Document last modified: 6/12/15

<u>Page</u>	<u>Correction</u>
iii	Karl Kerchner , Lebanon County Conservation District
3	URL link has been changed to: http://www.deq.virginia.gov/Portals/0/DEQ/Water/Publications/TechBulletin1.pdf
35	3 rd paragraph, 1 st sentence: 2,000 cubic feet storage capacity (with 12” freeboard) for each tributary drainage acre.
62	Last paragraph, 1st sentence: “As with other sediment barriers, compost socks should not be placed in areas of concentrated flow. They should be placed parallel...”

124 Equation for 10-year storm

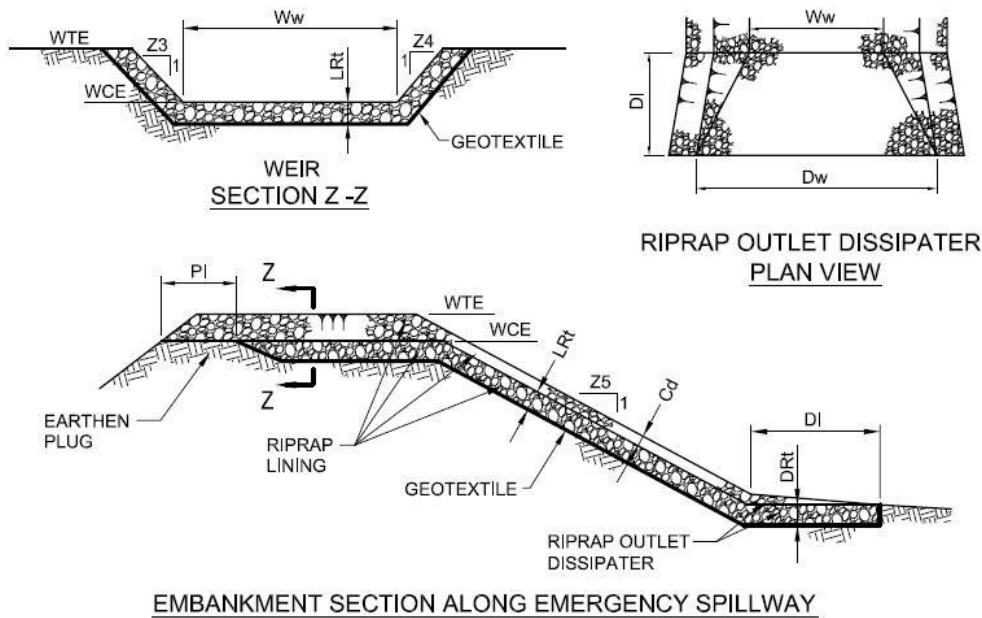
$$I = \frac{170}{T_c + 23} = \frac{170}{26.19 + 23} = \frac{170}{49.19} = 3.46 \text{ in / hr}$$
